P.O.A.D.P.
LONE STAR BUSINESS PARK
SOUTHEAST CORNER OF IH 10 AND UTSA BLVD.
CITY OF SAN ANTONIO, BEXAR COUNTY, TEXAS

Re: Lone Star Business Park

POADP # 591

P.O.A.D.P. REVIEW

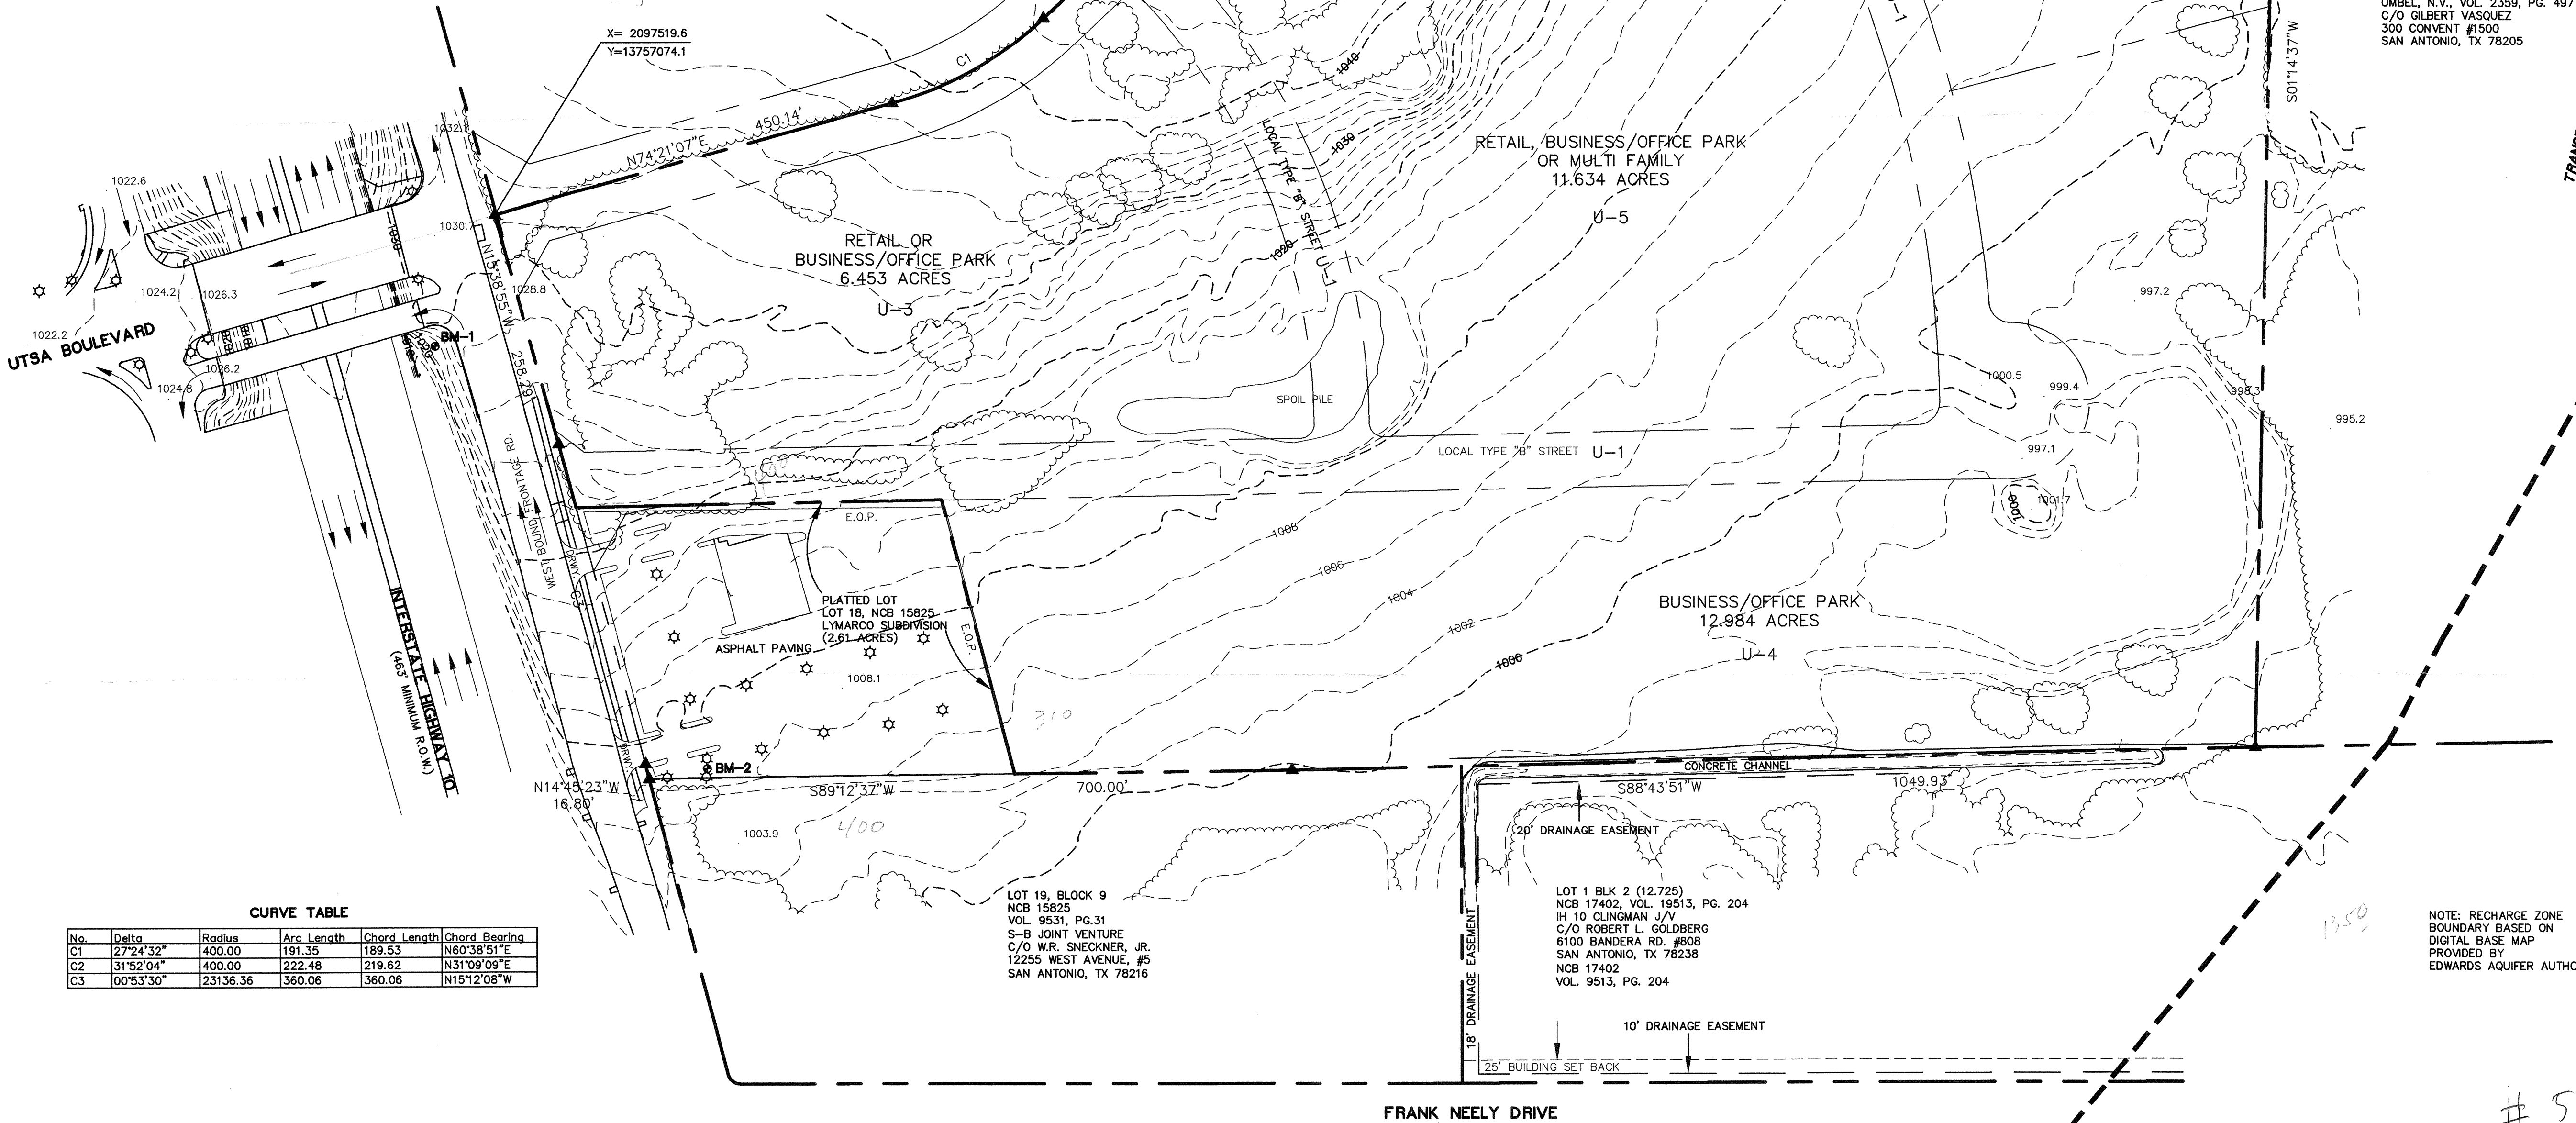
- Based on the topography, a Flood Plain Study and drainage review will probably be required during the platting process.
- UTSA is a Secondary Type A Major Thoroughfare, and will require a total of 86' of ROW.
- Access and R.O.W. issues along State facilities will need to be resolved with the Texas Department of Transportation (TXDOT). For additional information about these requirements you can contact TXDOT at 615-5814.
- This development will need to comply with tree preservation ordinance #85262. For additional information about these requirements you can contact Building Inspections at 207-7102.

Comments: Drainage Easements will be require
and will be address during the platting
process.

For residential development directly adjacent to State ROW, the developer shall be responsible for adequate set-back and/or sound abatement.

50' ROW flares will be required at the intersection of the planned local type "B" street and the IH 10 frontage road and at the intersection of the planned UTSA Boulevard extension and the IH 10 frontage road.

The property identified as Tract 1 (2.61 acres) is eligible for one access point to the IH 10 frontage Road. All access to the property identified as Tract 8 (2.45) acres shall be from the planned local type "B" street and the planned UTSA Boulevard extension. Locations of access points will be as directed by "Regulations For Access Driveways to State Highways".

Permit applications along with plans for street, driveway, utility, sidewalk and drainage construction must be submitted to the Texas Department of Transportation for review and approval before working on highway ROW. TxDOT requires that a recorded plat accompany all driveway permit applications. The Owner/Developer is responsible for preventing any adverse impact to the existing drainage system within highway ROW.
